REMARKS/ARGUMENTS

Appn No. 10/699,765
Reply to Office action
of June 24, 2005
Annotated Sheet showing
Drawing Changes

Fig. 4

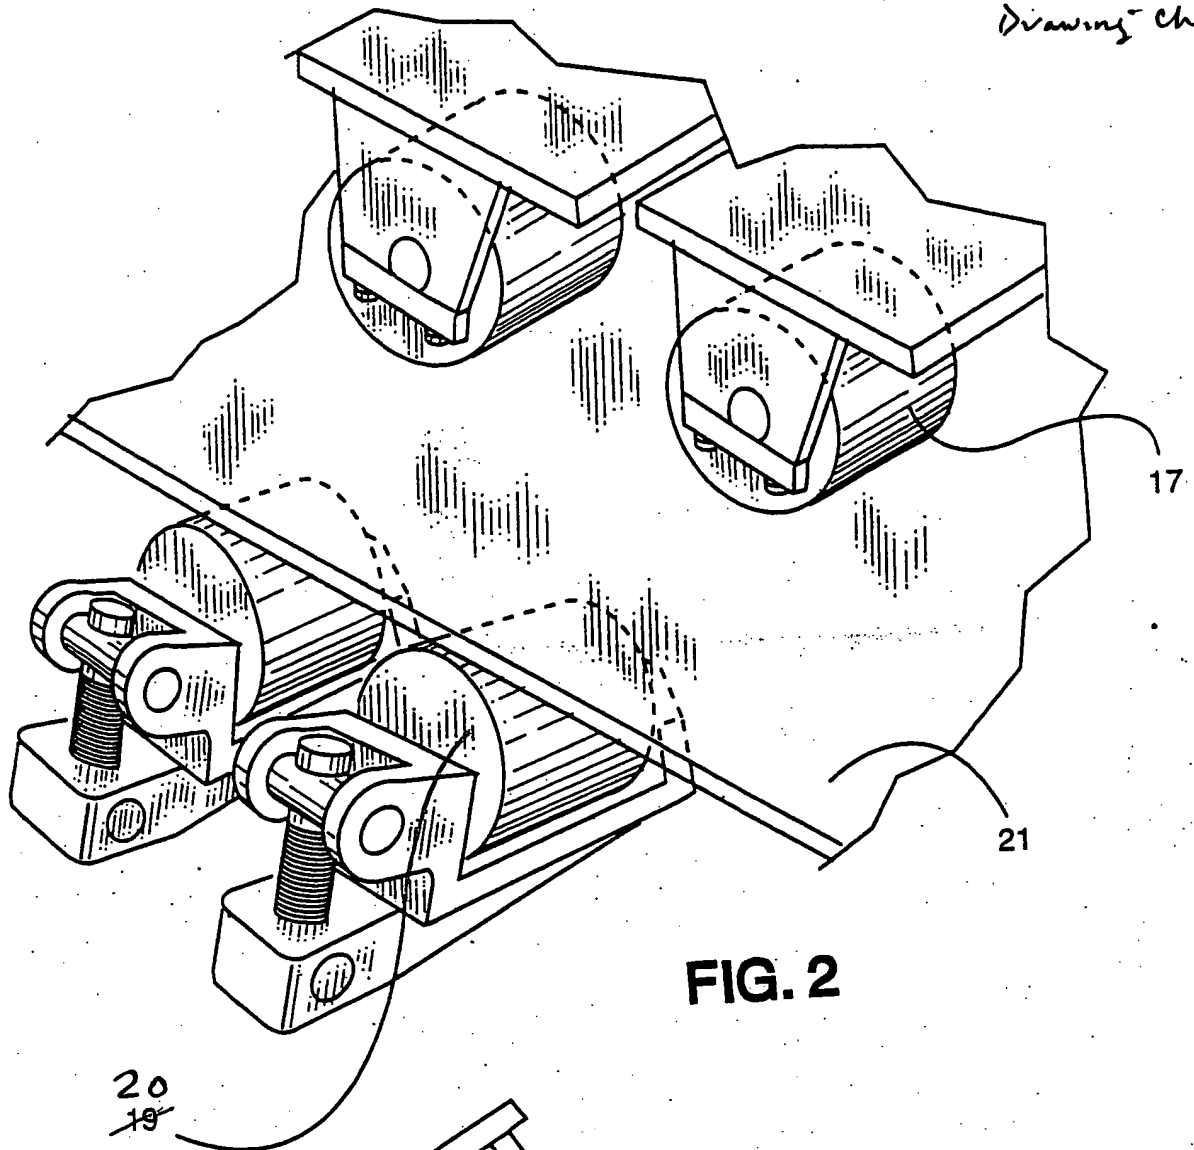
The Examiner objected to the drawings in that the longitudinal roller set 20 was not shown in Figure 2 and that element 19 was not mentioned in the Specification. The Examiner also pointed out the misspelling of the word "austenite" in Figure 4. Applicant has made the required drawing changes and replacement drawing sheets are attached as a part of this response.

The attached two sheets of drawings include changes to Figures 2 and 4. These attached two sheets, which include Figures 2 and 4, replace the original sheets including Figures 2 and 4. In Figure 2, the number "19" referring to the lower roller set has been corrected to "20" so that the drawings agree with the language of the Specification as originally filed. In Figure 4, the spelling of the term "austerite" has been corrected to "austenite." Also attached are annotated sheets showing the drawing changes in red.
